Appendix E: Pedestrian Rights-of-Way Reports

Sample Curb Ramp Key Map of Downtown Core. Complete Map Available Upon Request

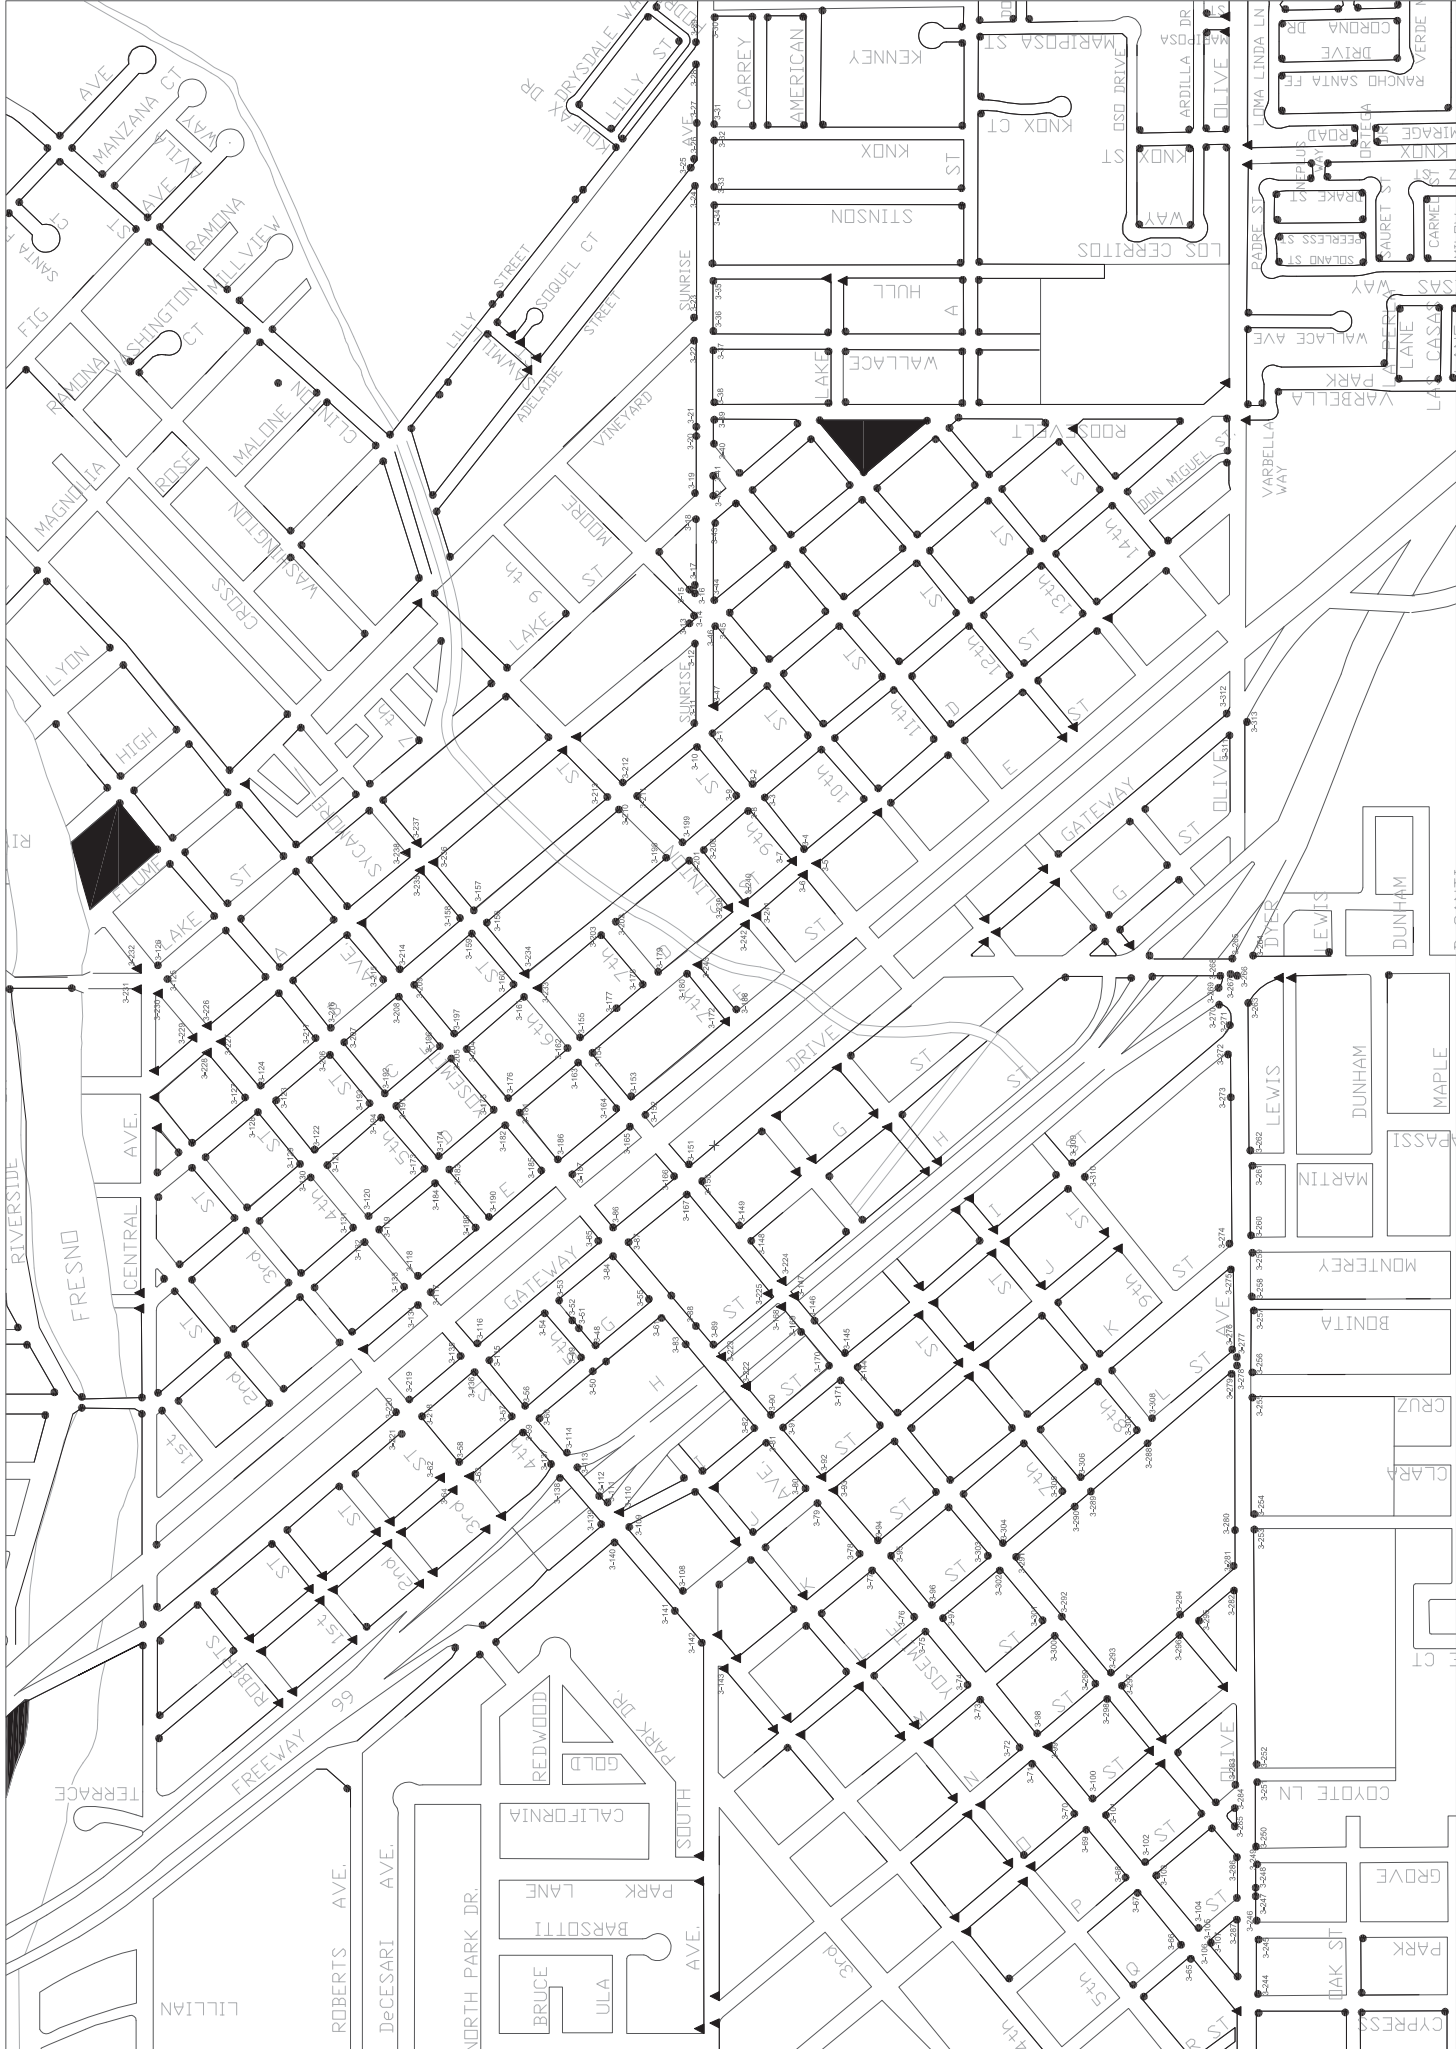
Exterior		
3 - 1	Curb Ramp	Priority:
Install, replace or modify curb ramp		\$3,500
Notes: Slope of curb ramp is 10.3% (8.33% max). Slopes of flared sides are 13.8% and 10.1% (10% max). There is not a 24" min. segment of straight curb on each side of the curb ramp.		
State: 1127B.5 #3, 1127B.5 #9		
Federal: 4.7.10, 4.7.5, 4.8.2		
Provide level landing		\$2,000
Notes: Slope of gutter pane is 11.9% (5% max).		
State: 1127B.5 #3		
Federal: 4.7.2		
Repair surface		\$0
Notes: There is a 1/2" lip at the bottom of the curb ramp. Grind lip down so that transitions from the curb ramp to the street is flushed and free of abrupt changes.		
State: 1133B.7.4		
Federal: 4.7.2		
Provide detectable warning strip		\$0
Notes: Detectable warnings are not provided.		
State: 1127B.5 #7		
Federal: 4.7.7		
Provide surface texturing		\$0
Notes: Surface material does not contrast with surrounding sidewalks.		
State: 1127B.5 #5		
Federal: -

Exterior		
3 - 2	Curb Ramp	Priority:
Install, replace or modify curb ramp		\$3,500
Notes: Slope of curb ramp is 9.6% (8.33% max). Slopes of flared sides are 10.5% and 10.6% (10% max). Space at the bottom of the curb ramp is 27" x 48" (48" x 48" min) clear. 24" segment of straight curb is not within marked crossings.		
State: 1127B.5 #3, 1127B.5 #4, 1127B.5 #9		
Federal: 4.7.10, 4.7.5, 4.8.2		
Provide level landing		\$2,000
Notes: Slope of gutter pane is 10.8% (5% max).		
State: 1127B.5 #3		
Federal: 4.7.2		
Repair surface		\$0
Notes: There is a 1/2" lip at the bottom of the curb ramp. Grind lip down so that transitions from the curb ramp to the street is flushed and free of abrupt changes.		
State: 1133B.7.4		
Federal: 4.7.2		
Provide detectable warning strip		\$0
Notes: Detectable warnings are not provided.		
State: 1127B.5 #7		
Federal: 4.7.7		
Provide surface texturing		\$0
Notes: Surface material does not contrast with surrounding sidewalks.

Exterior		
3 - 3	Curb Ramp	Priority:
Install, replace or modify curb ramp		\$3,500
Notes: Slope of curb ramp is 9.2% (8.33% max). Slope at the top landing is 2.2% (2% max). 24" segment of straight curb is not within marked crossings.		
State: 1127B.5 #3, 1127B.5 #4, 1127B.5 #9		
Federal: 4.7.10, 4.8.2		
Provide level landing		\$2,000
Notes: Slope of gutter pane is 9.3% (5% max).		
State: 1127B.5 #3		
Federal: 4.7.2		
Repair surface		\$0
Notes: There is a 1/2" lip at the bottom of the curb ramp. Grind lip down so that transitions from the curb ramp to the street is flushed and free of abrupt changes.		
State: 1133B.7.4		
Federal: 4.7.2		
Provide detectable warning strip		\$0
Notes: Detectable warnings are not provided.		
State: 1127B.5 #7		
Federal: 4.7.7		
Provide surface texturing		\$0
Notes: Surface material does not contrast with surrounding sidewalks.		
State: 1127B.5 #5		
Federal: -

Exterior		
3 - 4	Curb Ramp	Priority:
Install, replace or modify curb ramp		\$3,500
Notes: Slope of curb ramp is 12.4% (8.33% max). Slopes of flared sides are 12.8% and 12.9% (10% max). Slope at the top landing is 3.3% (2% max). 24" segment of straight curb is not within marked crossings.		
State: 1127B.5 #3, 1127B.5 #4, 1127B.5 #9		
Federal: 4.7.10, 4.7.5, 4.8.2		
Provide level landing		\$2,000
Notes: Slope of gutter pane is 11.9% (5% max).		
State: 1127B.5 #3		
Federal: 4.7.2		
Repair surface		\$0
Notes: There is a 1/2" lip at the bottom of the curb ramp. Grind lip down so that transitions from the curb ramp to the street is flushed and free of abrupt changes.		
State: 1133B.7.4		
Federal: 4.7.2		
Provide detectable warning strip		\$0
Notes: Detectable warnings are not provided.		
State: 1127B.5 #7		
Federal: 4.7.7		
Provide surface texturing		\$0
Notes: Surface material does not contrast with surrounding sidewalks.
